Staff Review of Concept Plan Submittal

Re: Deer Springs – Future Phase Proposal

Date: September 15, 2021

Re: Rezone Application for Deer Springs (Future Phase)

Proposed Site Layout

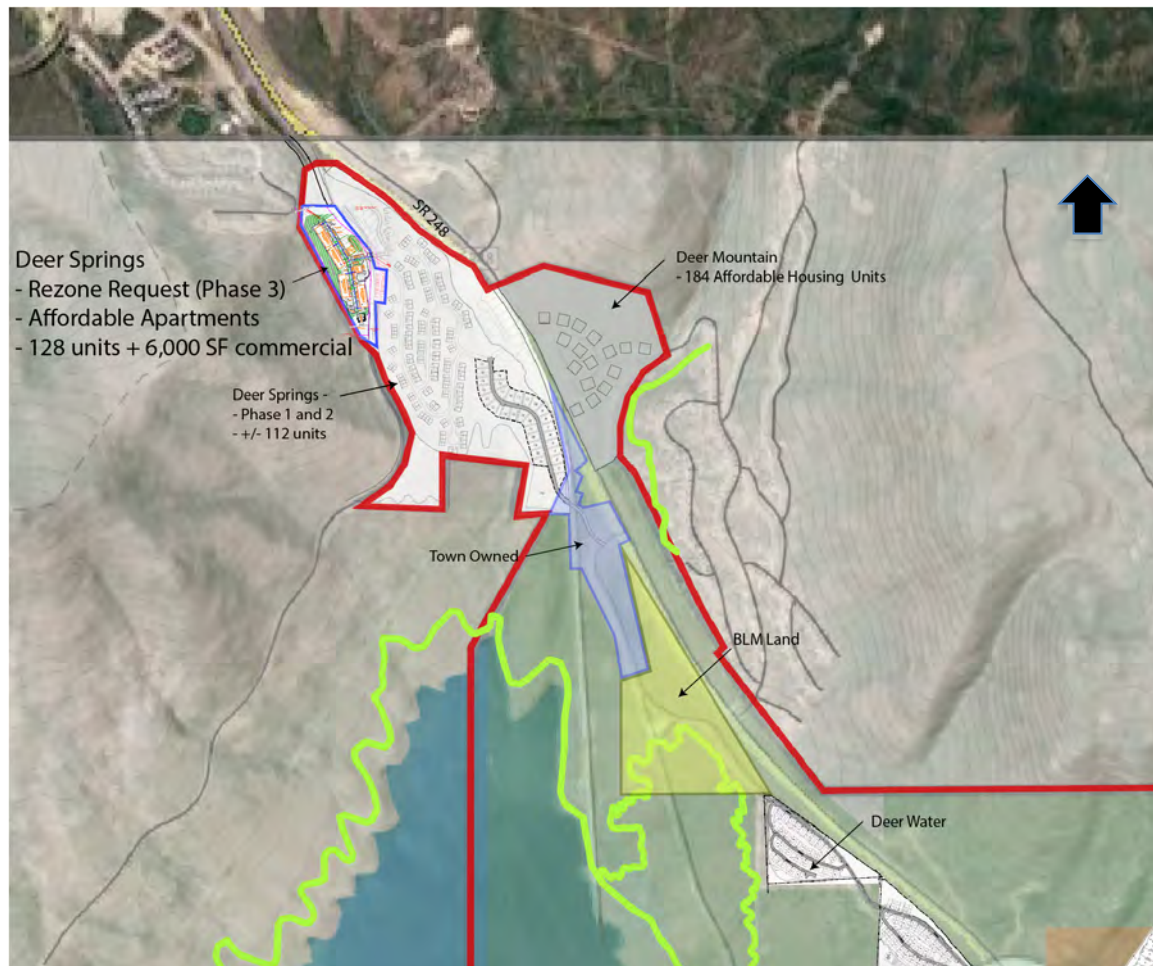
* Applicant to provide an upslope elevation and downslope elevation.

The slope of the land is such that any development will likely require significant retaining walls (and exposed building footings) on the downslope side. Is the owner prepared to address the functional (engineering) and aesthetic (Town character preservation) issues that are certain to arise? To what extent is the Town willing to alter the community character?
